Final Safety Evaluation Report for Combined Licenses for Turkey Point Units 6 and 7

U. S. Nuclear Regulatory Commission
Office of New Reactors
Washington, DC 20555-0001

November 2016

This final safety evaluation report¹ (FSER) documents the U.S. Nuclear Regulatory Commission (NRC) staff's technical review of the combined license (COL) application submitted by the applicant for Turkey Point Units 6 and 7 by Florida Power & Light Company (FPL).

Figure 14. Fault Maps of Cuba Showing Earthquakes from the Project Phase 2 Earthquake Catalog (Sheet 1 of 3) (Turkey Point Units 6 and 7 COL FSAR Figure 2.5.1-368). Multiple sources used to compile this map, including Turkey Point Units 6 and 7 COL FSAR Refs. 439, 448, 492, and 494.

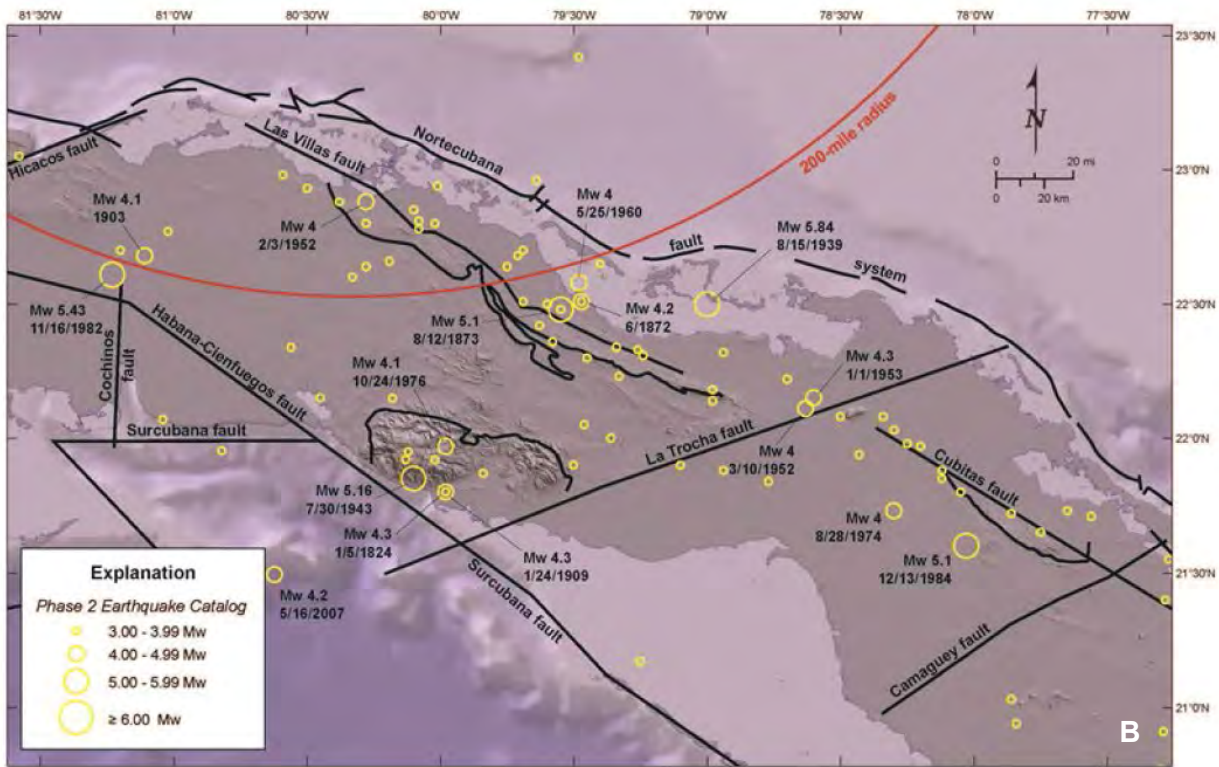
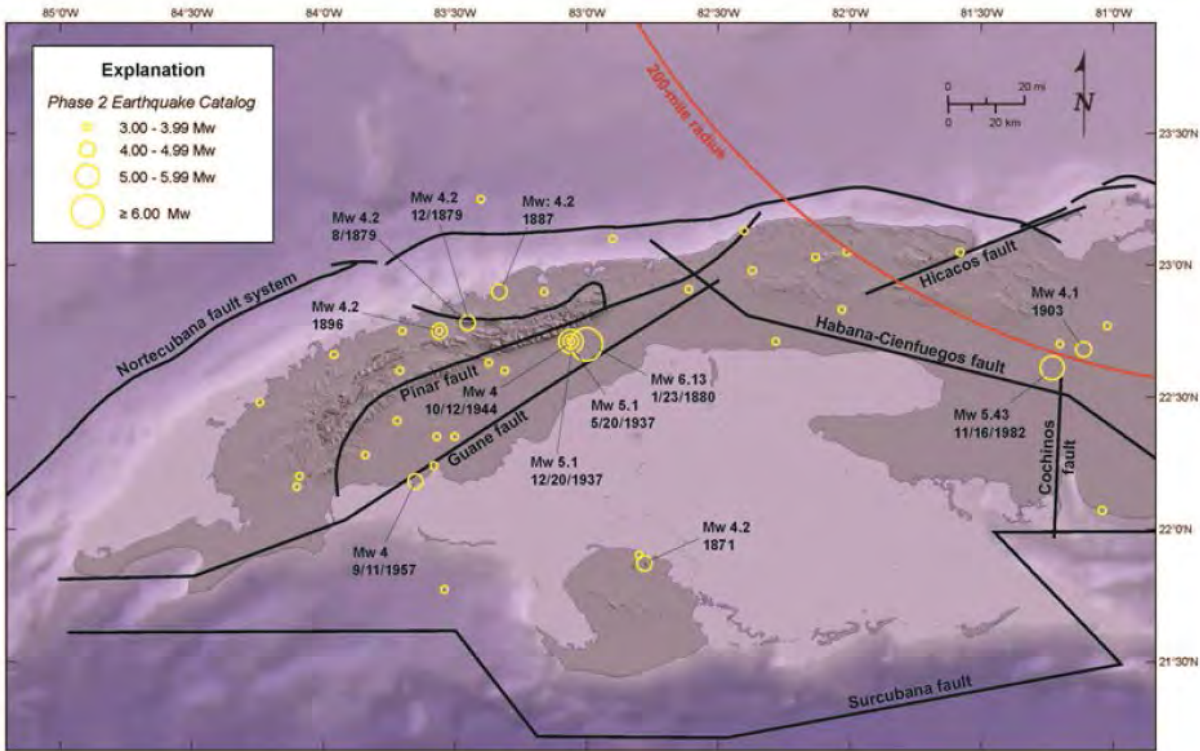
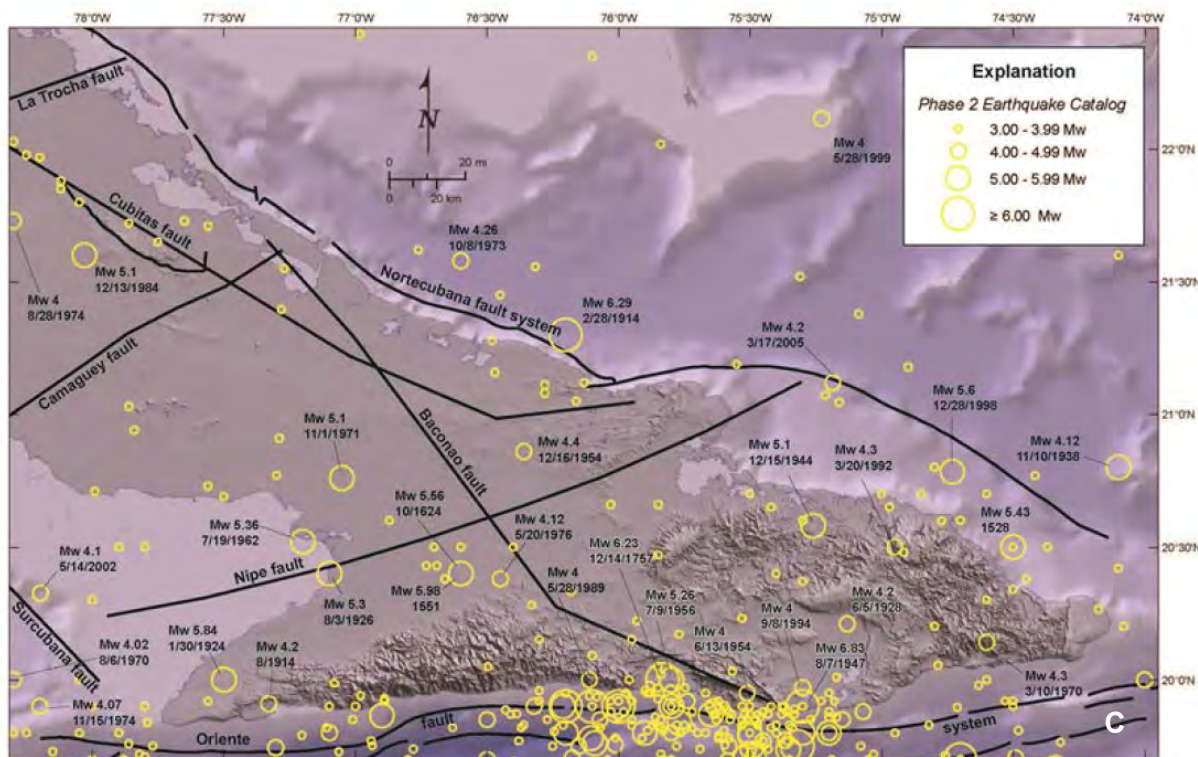
In response to several RAIs regarding Cuba faults and seismicity (RAI 41, Questions 02.05.01-21, -24 through 30) (ADAMS Accession Nos. ML14282A078, ML14282A079, and ML14282A079) dated October 3, 2014, the applicant made a general statement that the lack of permanent seismic recording stations in Cuba, especially for lower-magnitude earthquakes, limits the accuracy of earthquake locations; that earthquakes in Cuba do not appear to correlate strongly with faults; and the Phase 2 earthquake catalog was used to consider the possibility of seismicity associated with a specified fault (Figure 2.5.1-14). The staff notes that the Phase 2

In a June 8, 2015 response to RAI 81, Question 02.05.01-35 (ADAMS Accession No. ML15160A574) the applicant responded that a declustered or mainshock Phase 2 earthquake catalog was used to compute recurrence parameters for the Cuba seismic source characterization. The applicant agrees with the staff that in the Cuba region that mapping seismicity before the declustering earthquake process could be used in identifying potentially active, previously unidentified structures, if the earthquake association were unambiguous. Therefore, the applicant revised FSAR Figure 2.5.1-368 (Sheets 1 through 3) to include mainshock events of Mw and above 3.0, and foreshocks, aftershocks, and cluster events of Mw and above 3.0, and all small events mainshock and dependent events of Mw less than 3.0. The applicant also stated that the relevant text in Turkey Point Units 6 and 7 COL FSAR Section 2.5.1 will be revised accordingly. The applicant also stated that while the majority of the small-magnitude (Mw less than 3) seismicity is scattered and diffuse, seismicity patterns do show several clusters that are not part of the Phase 2 mainshock earthquake catalog Mw of 3 and above. Some of these earthquakes are not of sufficient size and definition to merit their consideration as fault sources. Other earthquake clusters are near faults that were included in a PSHA sensitivity study of the modeling of Cuba as a seismic source. The applicant concluded that when specific faults were considered as alternatives to the Cuba seismic source, they produced negligible impact on the total seismic hazard at the Turkey Point Units 6 and 7 site, as compared to the modeling of Cuba as a single areal seismic source zone (see FSAR Section 2.5.2.4.4.3.4.2.1). The staff evaluates the sensitivity analysis for the Cuba seismic source in RAI 41, Question 02.05.01-21 and RAI 5896, Question 02.05.02-4. Staff considers the revised Turkey Point Units 6 and 7 COL FSAR Figure 2.5.1-368 showing the total earthquake catalog of independent and dependent earthquakes sufficient response to this question and thus considers RAI 81, Question 02.05.01-35 resolved.
